APPLICATION FOR
URBAN DESIGN COMMISSION
REVIEW AND APPROVAL

PROJECT ADDRESS: 4841 Annamark Drive

Project Texas Roadhouse Madison, WI
Project # 20050922.2
Re Resubmittal: Urban Design Commission – Final Approval

WI-50922A6
SHEET 1 of 2

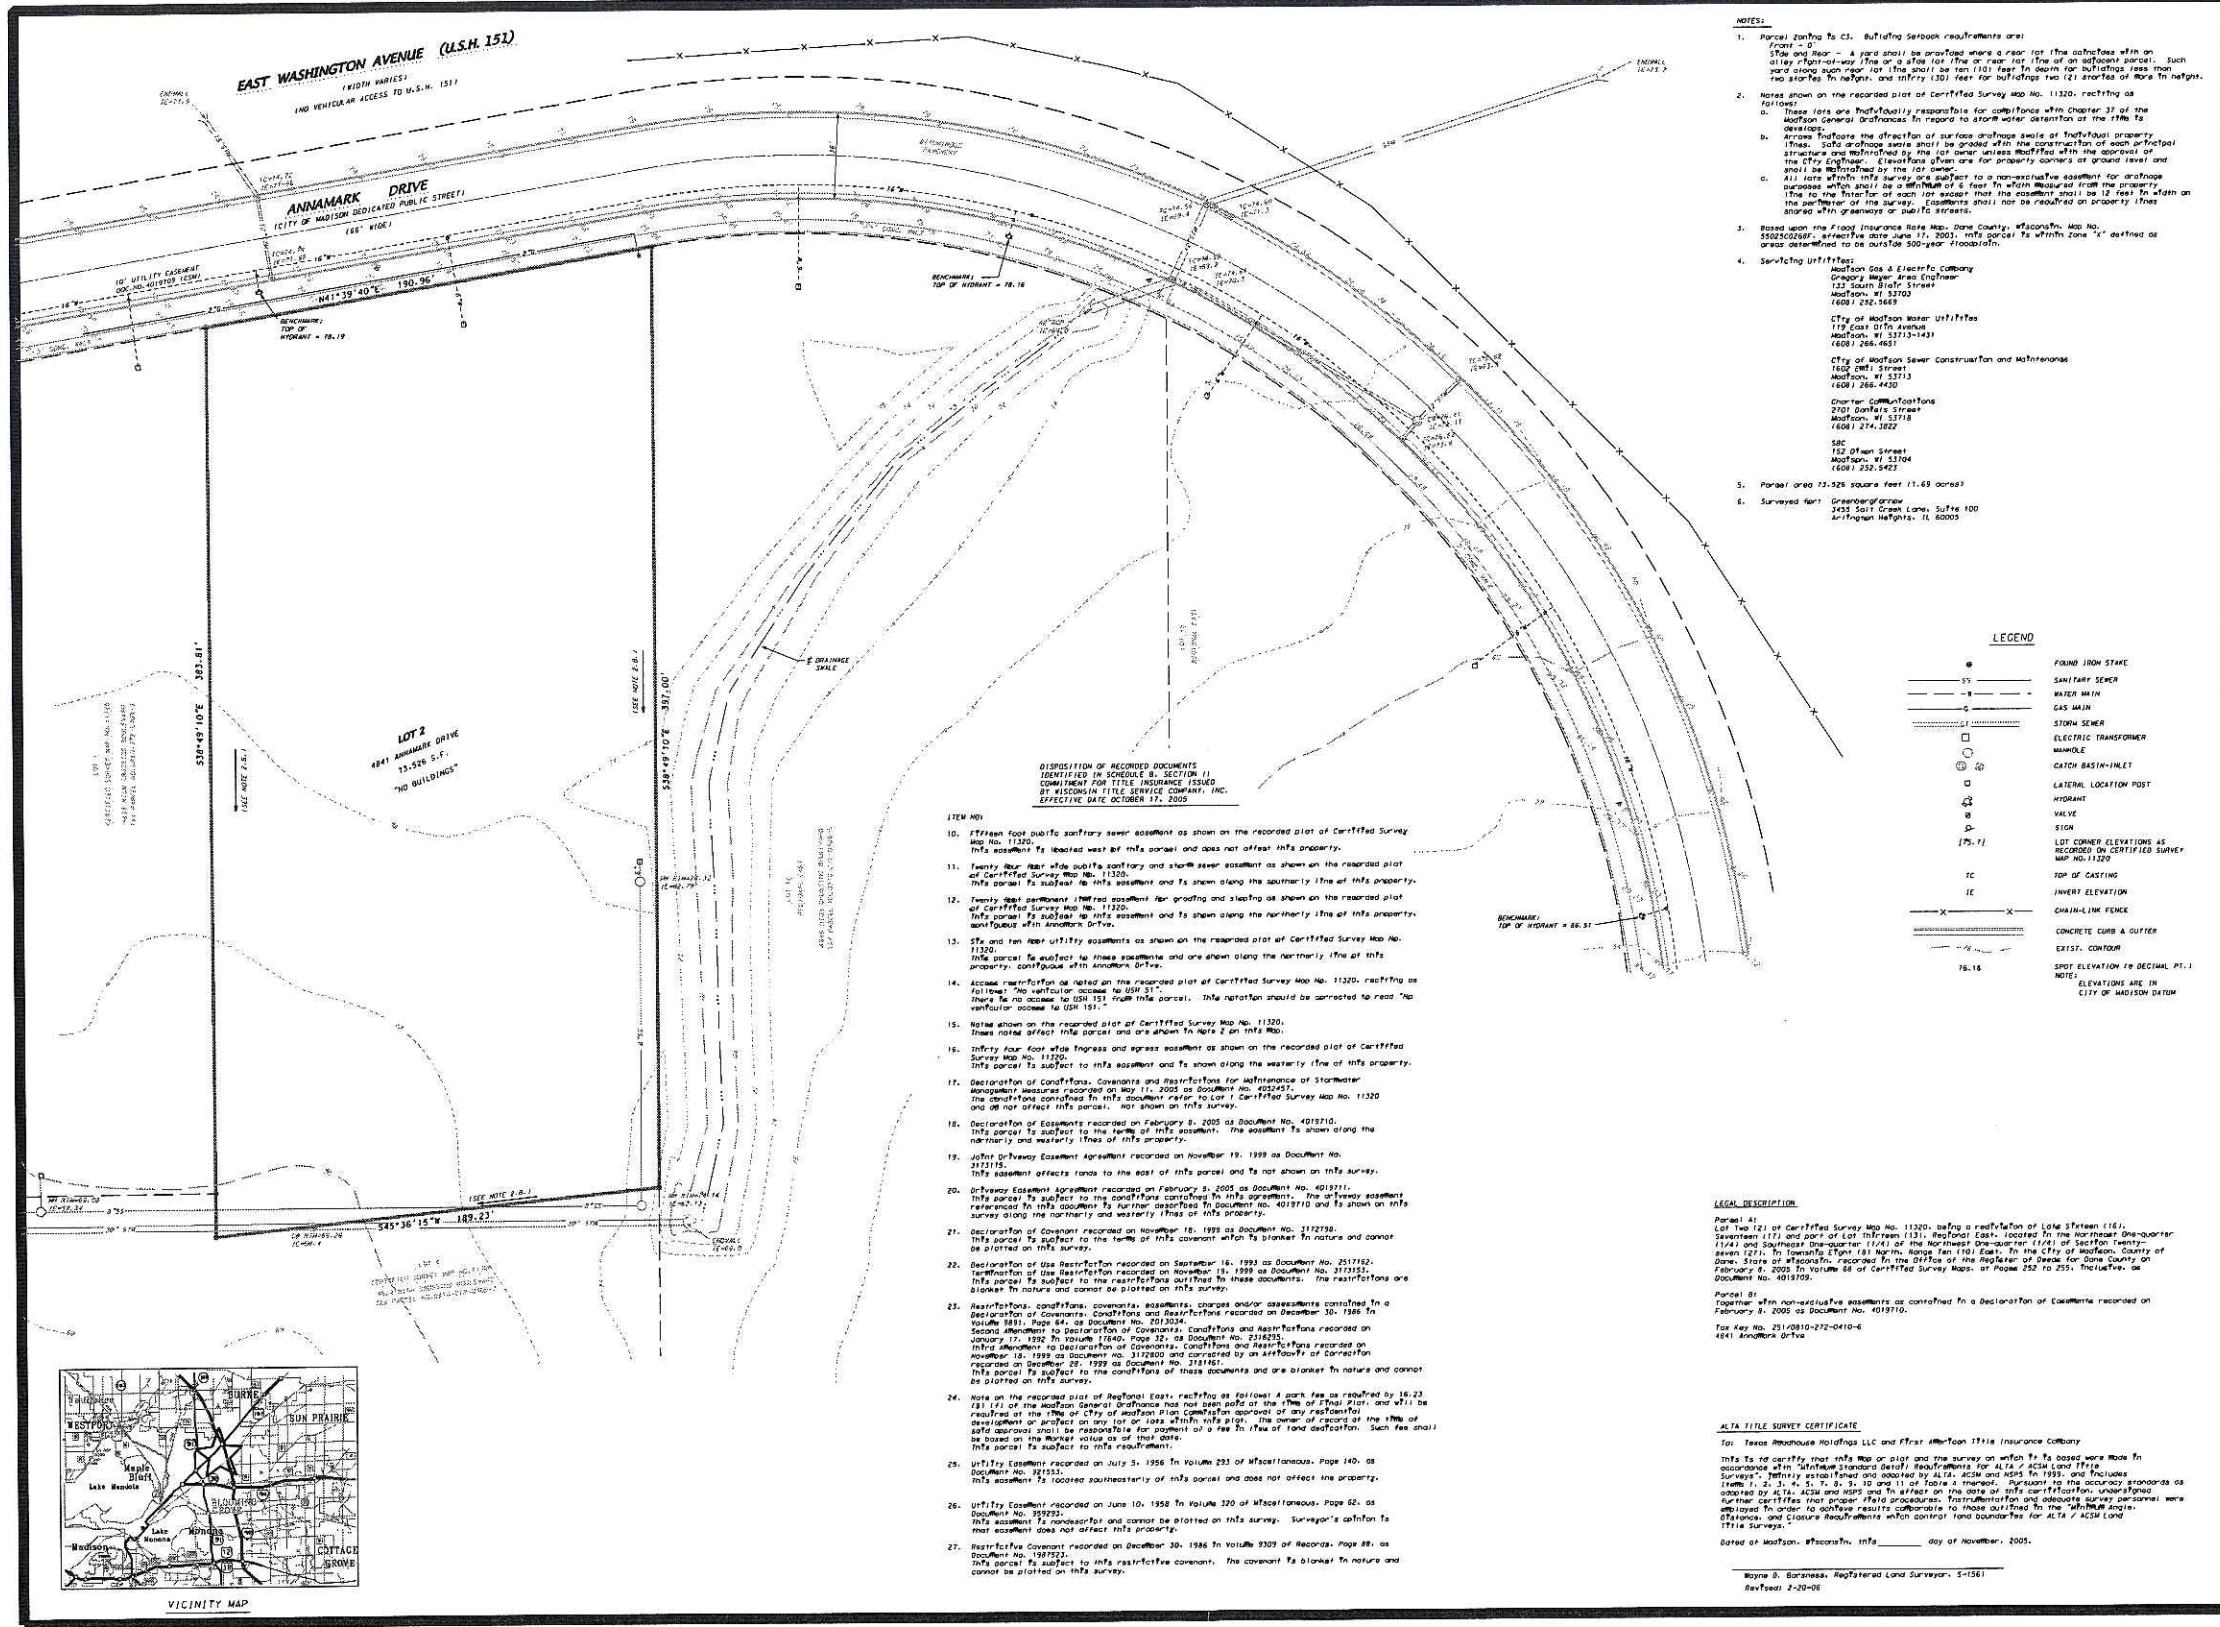
4. The landscape and site plans have been revised to incorporate several large deciduous trees along the northernmost row of parking along Annamark Drive. In order to eliminate a conflict with the pylon sign in this area, the sign was moved several parking spaces to the east. A new island was created around the base of the sign to afford enough room for landscaping. As such, the island that previously held the pylon sign was resized to accommodate the "lost" parking space for the new sign location. The total on-site parking count remains at 115 spaces.
5. The site plan was also revised to reflect a fire lane turnaround per Fire Department review comments.

SHEET NUMBER
C-7.0

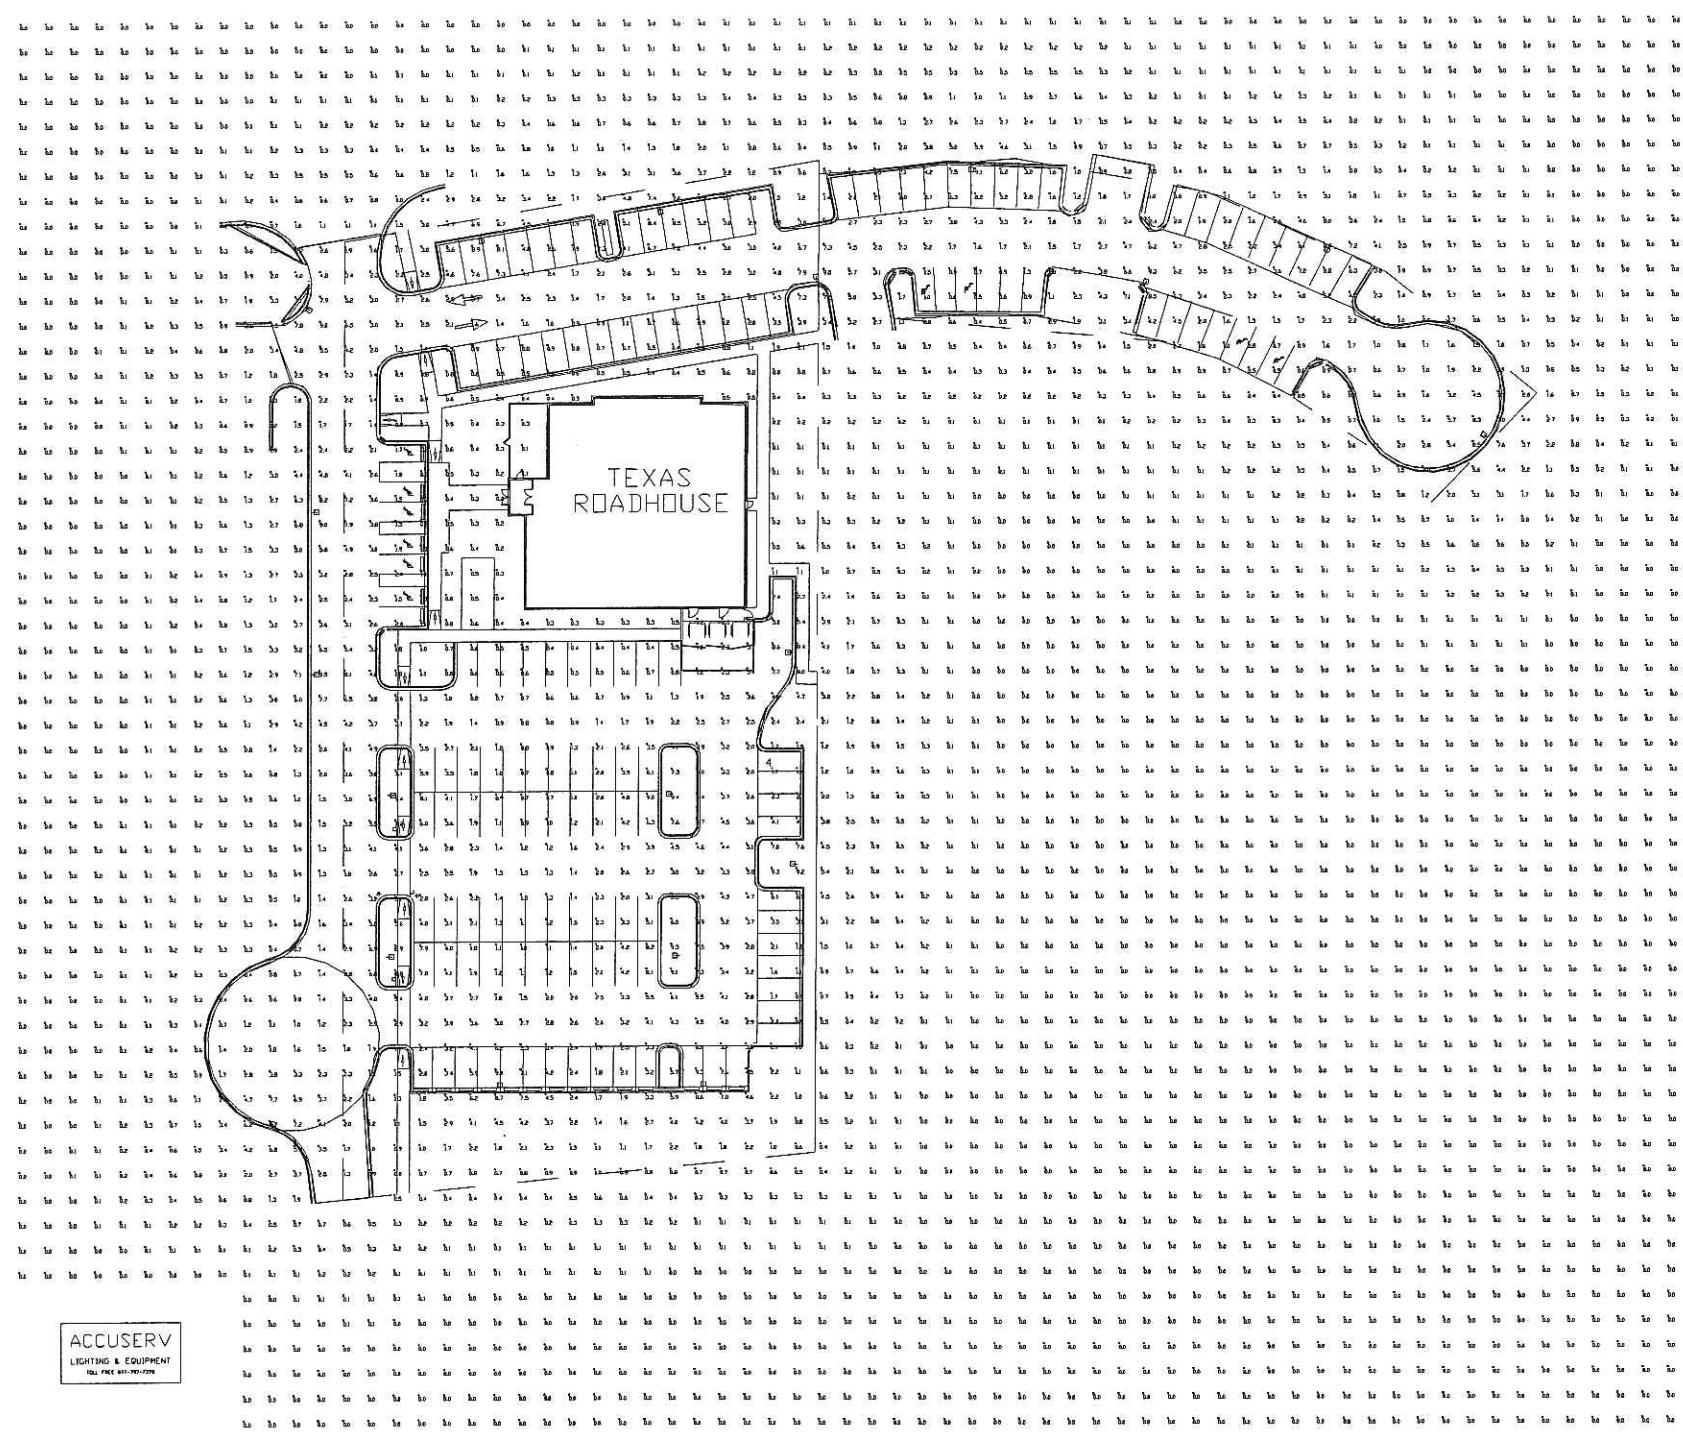
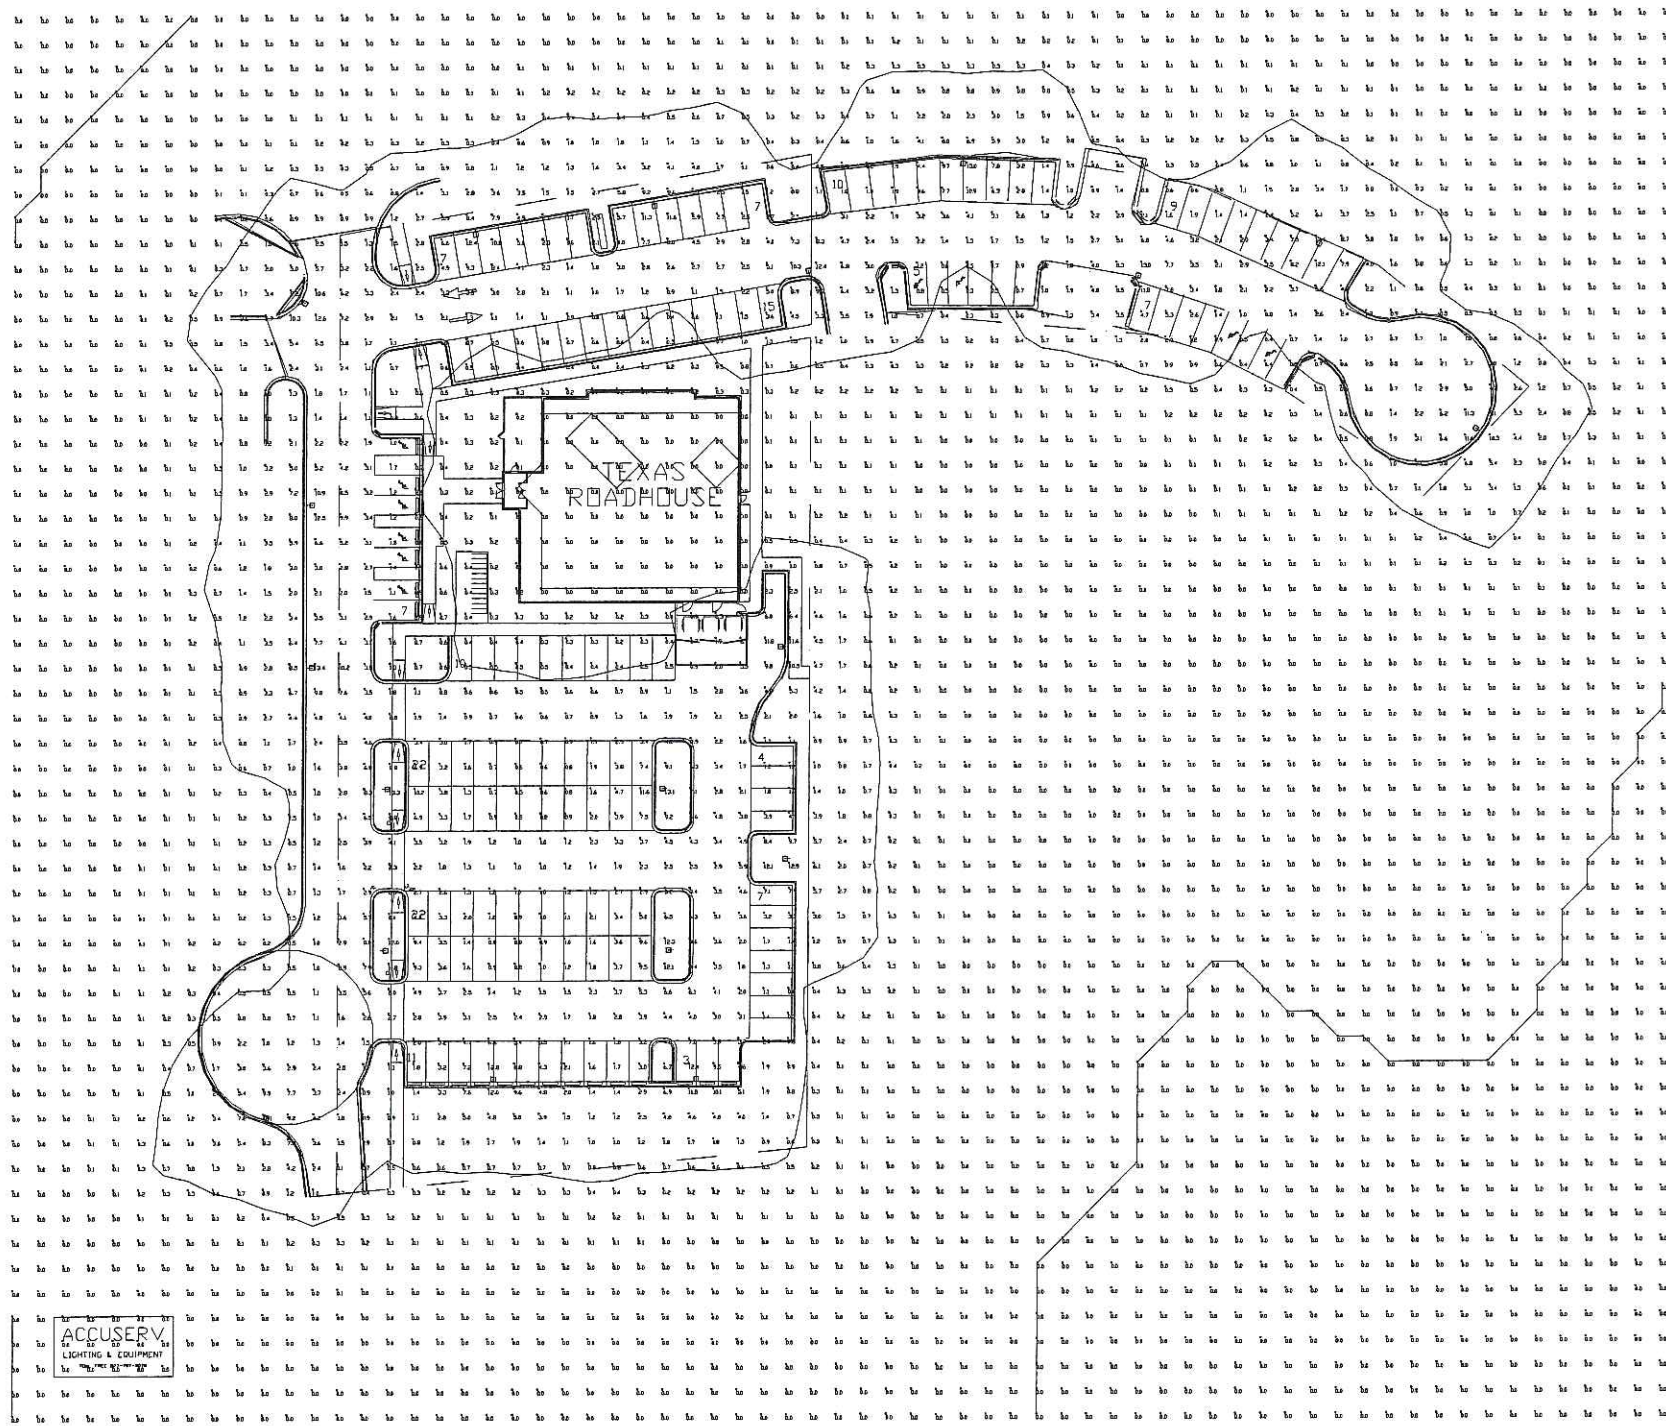
1. The photometric plan (Sheets C7.0 & C7.1 of the Civil Engineering Plan Set) has been revised to further reduce the "hot spots."
2. The architectural elevations have been revised to now show the "Type F12" emergency wall-pack fixtures located at the rear of the building. I have included the manufacturer's cut sheet for this wall-pack that indicates it is rated as a full cutoff fixture and is dark-sky approved.
3. The floor and seating plans have been updated to show the outdoor patio layout.
